S A V A N N A H H I S T O R I C D I S T R I C T
B O A R D O F R E V I E W

REQUEST FOR CERTIFICATE OF APPROPRIATENESS

MPC File No.: 25-005014-COA

Address: 318 East Huntingdon St.

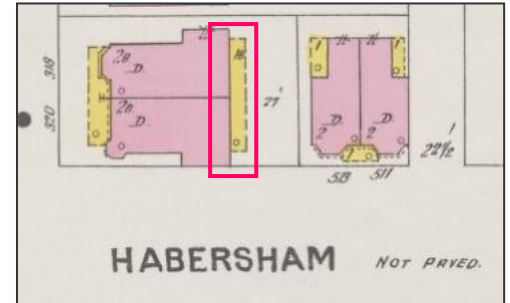
Google Street View images from 2016 and 2017 show what the rear porch looked like, in part, before the enclosure work began. In these images, the decorative wood porch elements can be

seen. These are still in existence but have now been enclosed with the current work that has taken place.

This addition obscures the character defining decorative wooden porch arches and columns. The other half of the property at 320 has a partial enclosure that leaves half of the historic porch still exposed. Perhaps a redesign may consider a similar option for 318.

The ordinance specifically states that rear porches may be screened with wire mesh, lattice, or shutters provided that the porch continues to read as a porch and character-defining features are not obscured. In this case the decorative wood arches were not removed but have been obscured. Thus, the standard is not met for these reasons.
